RE: Apple Cafeteria

I reviewed the drawings, and visited the site. My comments and recommendations are as follows:

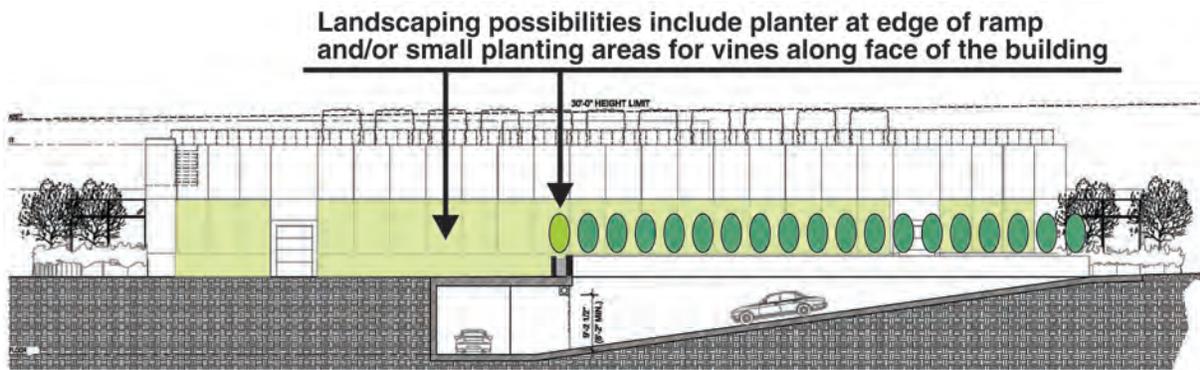
The only issue that I saw was the lack of landscaping at the north side of the structure to screen the view of what is essentially the service side of the building from street and sidewalk views along Bandlely Drive. My recommendation would be to consider moving the structure slightly toward Alves Drive to allow some buffer landscaping. Since the parcel zoning is P (CG,ML,RES4-10), I assume that there is some flexibility regarding the Alves Drive building setback. Some slight shift of the structure to the south would probably have very limited visual impact given the substantial landscaping proposed along that frontage. The move would not need to be great - only enough to allow one or two narrow planting areas. Screening possibilities include planters at the edge of the garage ramp and trash enclosure and/or a lattice or greenscreen along the north facade of the structure.
